**RE: Dutch Bros. - 10001 Central Ave.**

The next Dutch Brothers site will be located at 10001 Central Ave. There are two existing drive pads off of Central and we intend to eliminate the westerly site entrance closest to the intersection of Parsifal Ave. The developer and I would like to invite you to join in either a Zoom or Google meeting that we will set up to discuss this site prior to our submittal of the TCL plan.

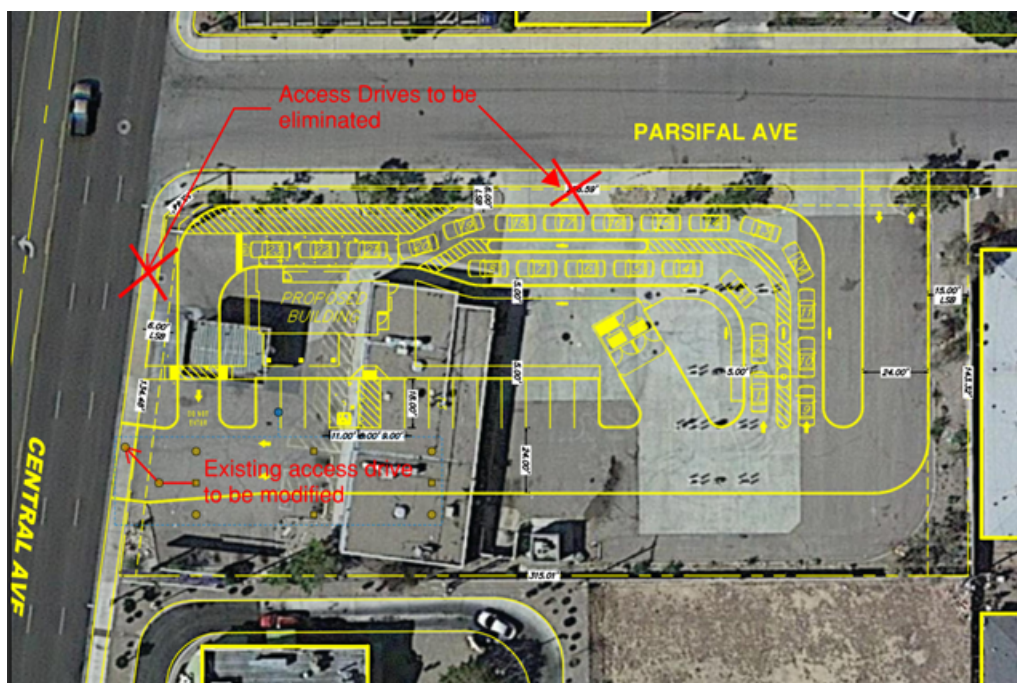
1. the distance from the east drive on Central to the Parsifal intersections is less than the 150' separation requirement and;
2. the 50' clear throat off of Central is shown as being less than 50'.

We would like to know if there are any variances that would allow for a shorter throat distance and since the existing entrance is being modified, is it grandfathered in and we do not have to comply with the 150' separation?

No problem, I can waive both those requirements as they appear to be dictated by site constraints. The queue length is the critical factor here.
